designed for: **R.De Salvo**

title: **HAM-OPTICAL BENCH**
DETAILS LVDT ACTUATOR

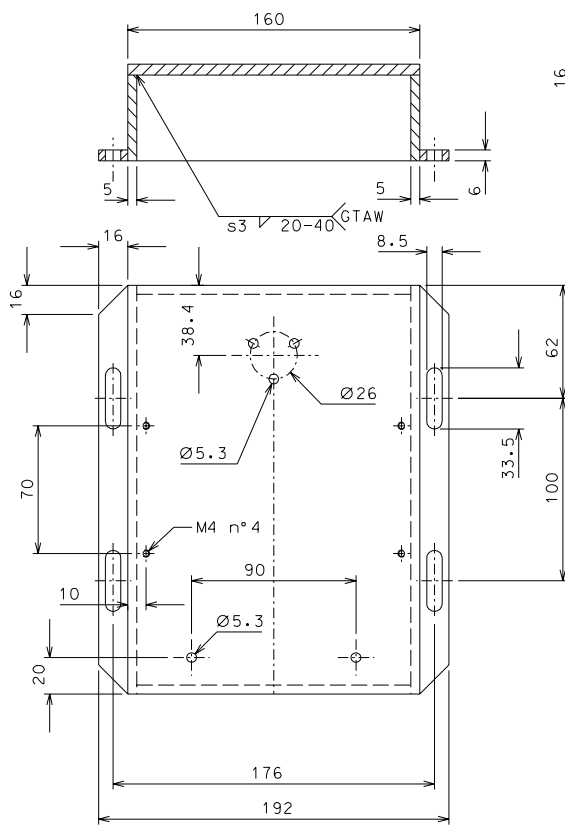
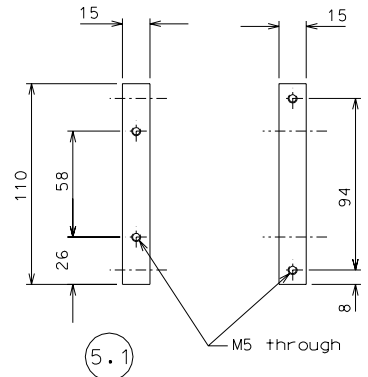
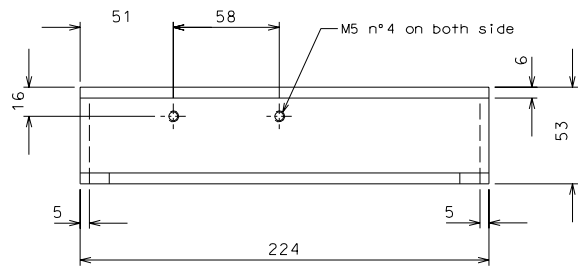
replaced the holes on the base				30-03-06
ref.	note	date	signature	
modifications				
6	4	AISI 304 L	1/2	
5.1	8	AISI 304 L	1/2	
5	4	AISI 304 L	1/2	
ref.	pieces	mat. and treatments	scale	
ref.	pieces	mat. and treatments	scale
